**Re: Decommission Irrigation Lagoon & Sinkhole
Remediation Plan for Bardane Industrial Park**

SUBJECT: **WWTP Lagoon Decommission & Sinkhole Remediation Plan**
Bardane Industrial Park, Jefferson County

WWTP and Lagoon Decommission Violation no. w17-19-026-mkk
Sinkhole UIC Permit Violation no. w17-19-025-mkk

BADANTE INDUSTRIAL PARK
 EXISTING DRAINAGE SYSTEM
 W/PT Lagoon
 &
 SINKHOLE PROJECT

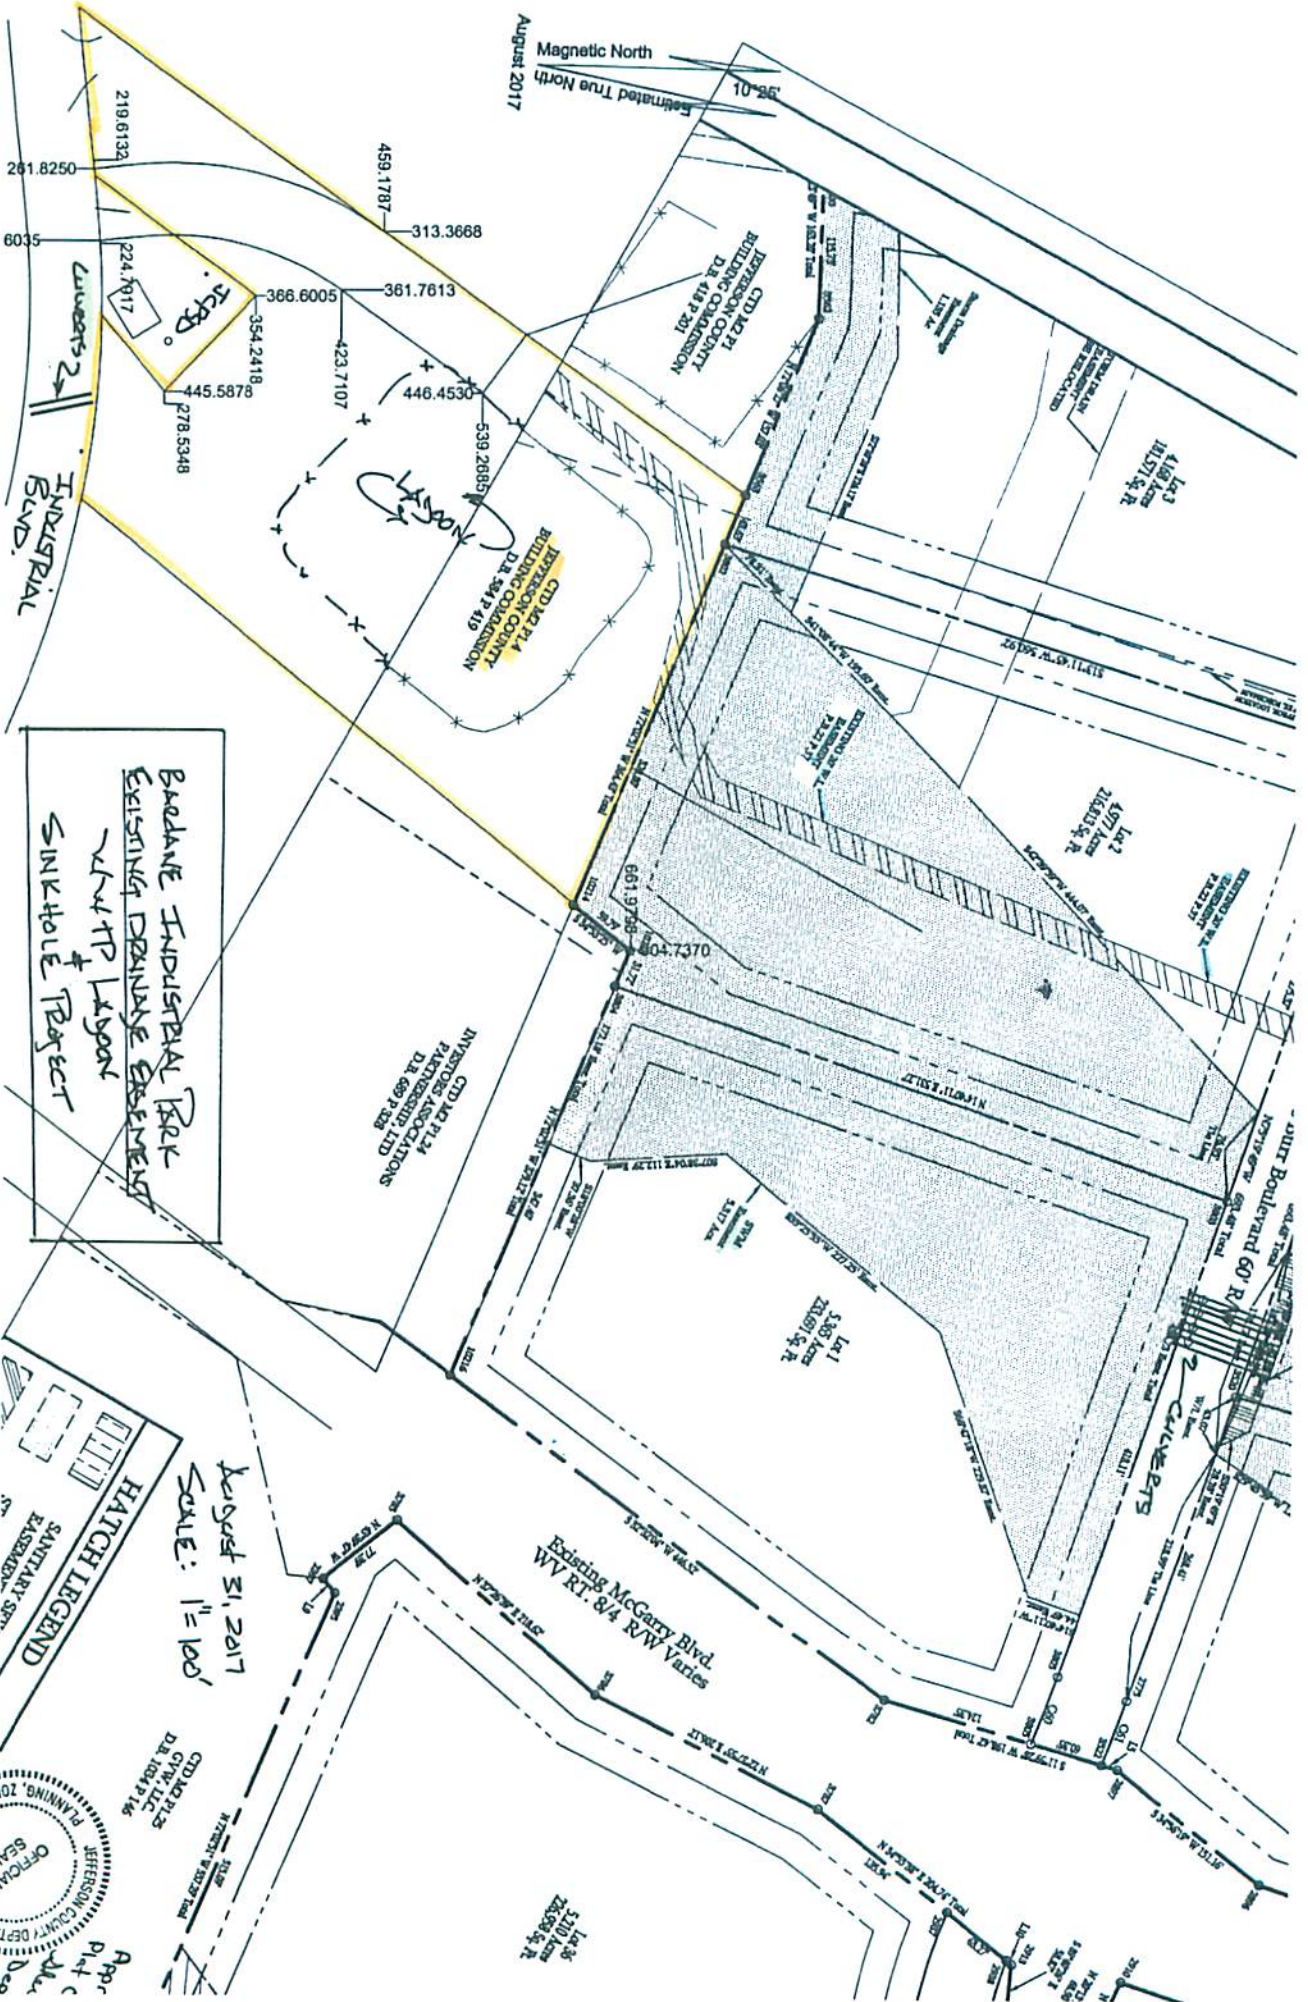
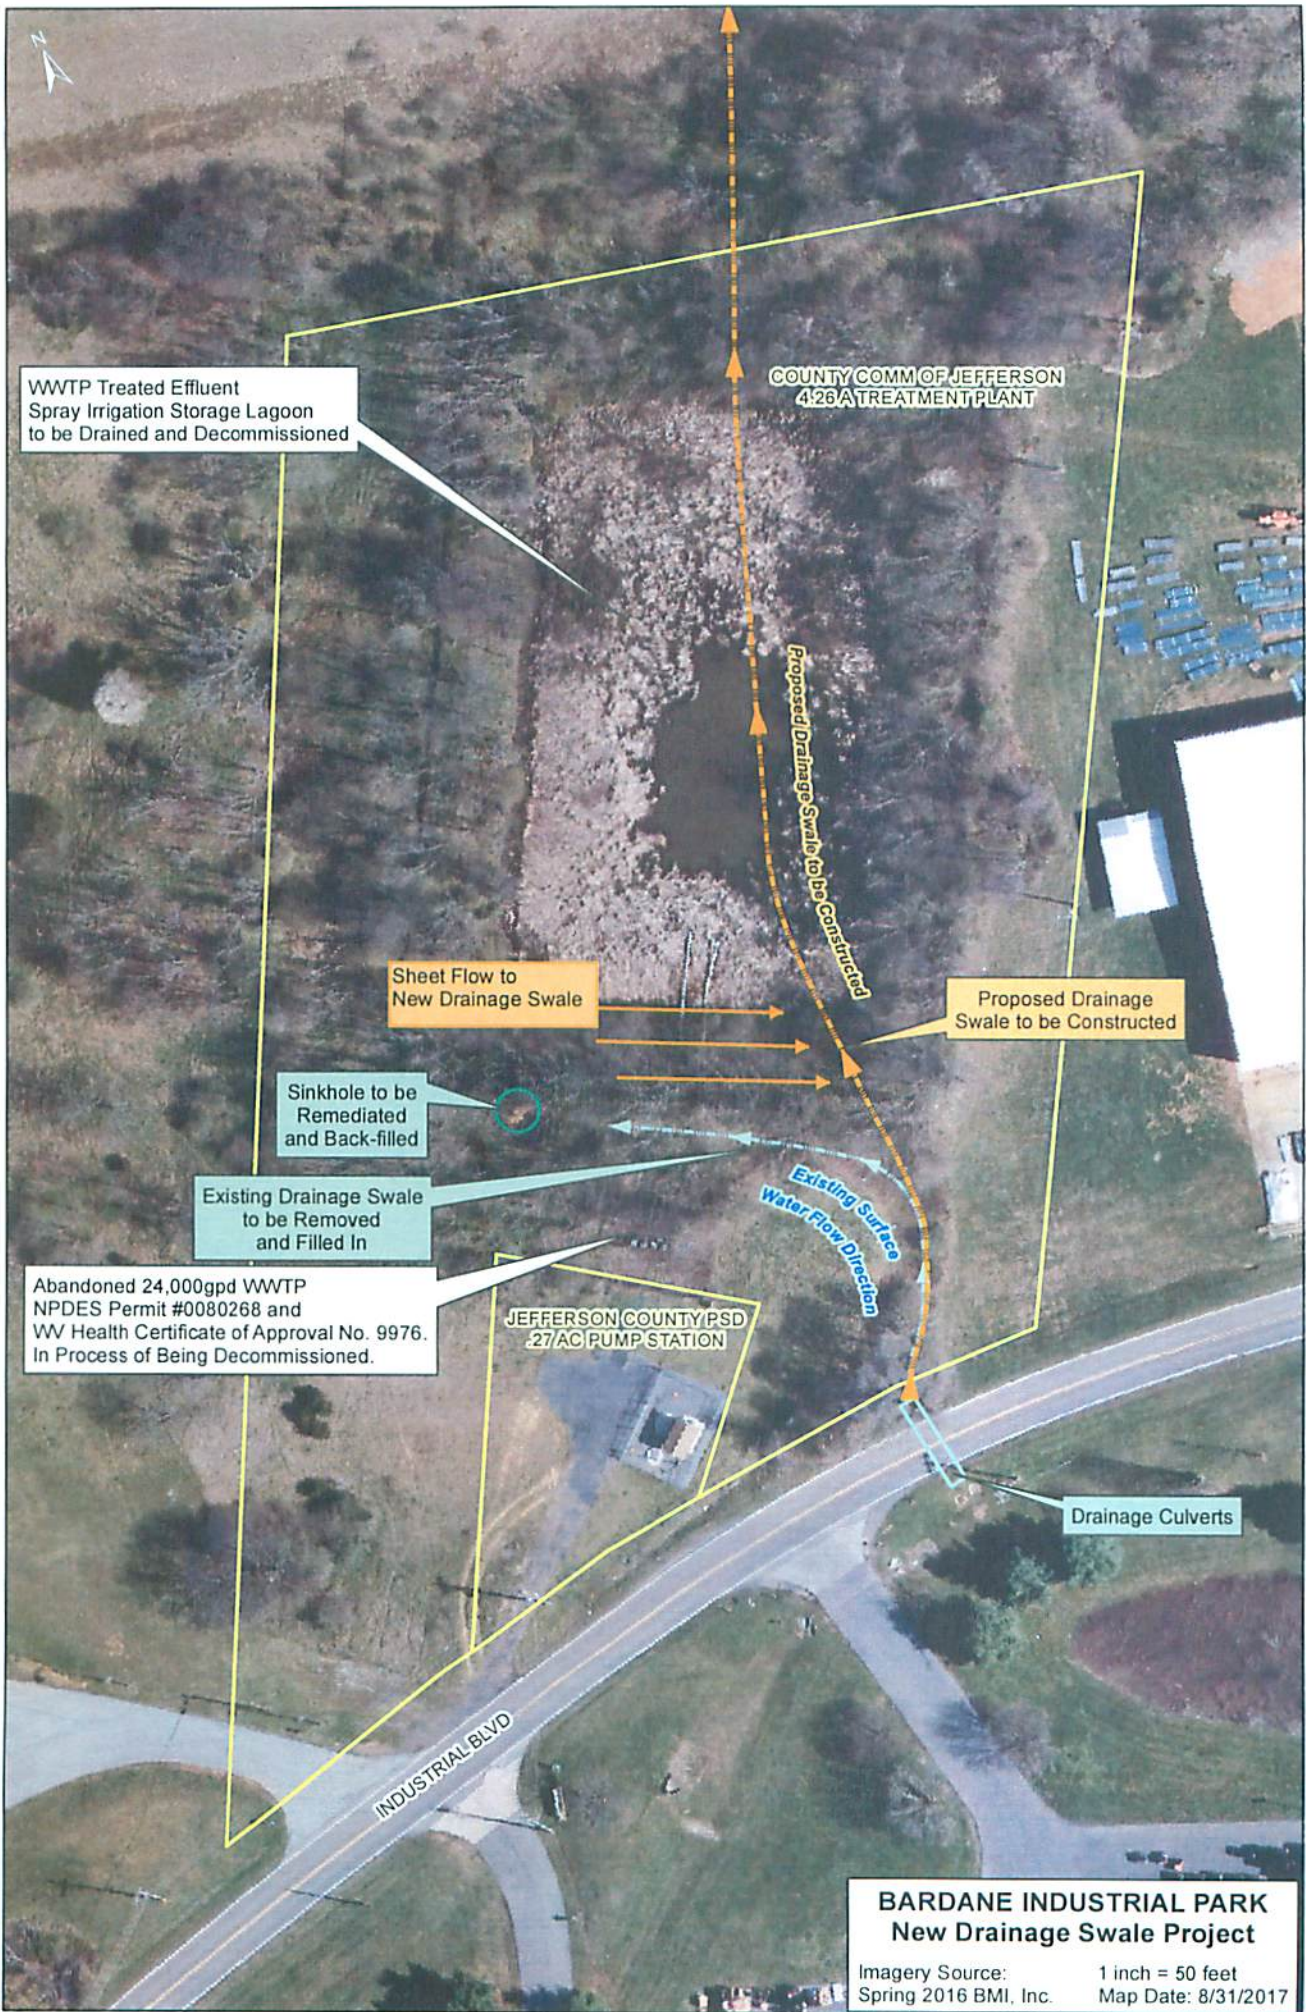
1. The work shall be performed in accordance with the letter, and all attachments, as presented, in the correspondence, dated August 31, 2017.
2. The sinkhole will be remediated in accordance with the applicable guidelines in the WVDEP Sinkhole Mitigation Guidance document.
3. All materials and equipment required to perform the work shall be on site prior to the initiation of the work activities.
4. The work activities shall be managed in a manner that will provide for the maximum alleviation of impact to, and maximum protection of, aquatic life and human health.

4. Once the new drainage swale is in place, the sinkhole will then be remediated in accordance with applicable guidelines in the WVDEP's Sinkhole Mitigation Guidance document (*see attached guidelines*). Fill will then be placed over the sinkhole and in the drainage swale that currently runs to the sinkhole. The fill will be graded toward the new drainage swale so that the stormwater runoff sheet/surface flows to the new drainage swale and not into the sinkhole (*see attached aerial site map showing proposed drainage swale*).
